ADDENDUM NO. 1

July 18, 2016

Contract No.: DK00144
TIP No.: EB-4411J
WBS Elements: 36333.3.FD10 & 2016CPT.11.18.10991
County: Yadkin
Description: Widening, Paving, Shoulder Construction, and Pavement Markings on NC 67
from SR 1549 to Bridge No. 35 over Yadkin River

TYPICAL SECTION NO. 1

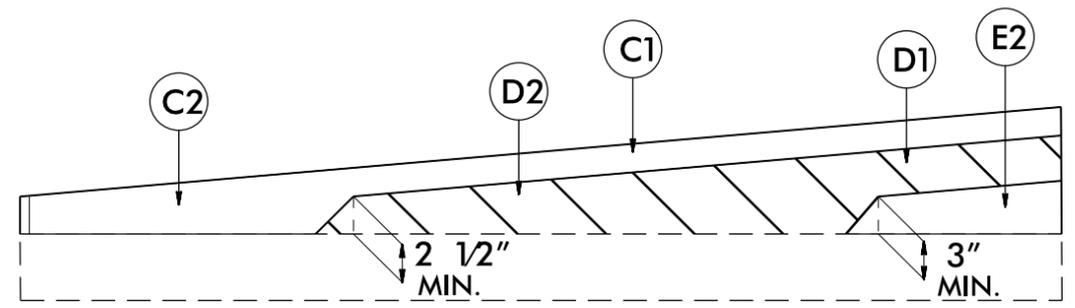
Reference is also made to the Project Plans for the above-mentioned project. The Typical Section found on Page 6 of the Project Plans has been revised to include pavement removal, up to 1' in width, within the existing pavement width to accommodate the 2' additional widening. The pavement removal areas will be denoted by the engineer and will be paid for as part of Pay Item # 2 (Grading).

T	EARTH MATERIAL
U	EXISTING PAVEMENT
V1	PAVEMENT REMOVAL - 9" MIN. DEPTH. PAID FOR AS PART OF GRADING.
W	VARIABLE DEPTH ASPHALT PAVING (SEE WEDGING DETAIL)
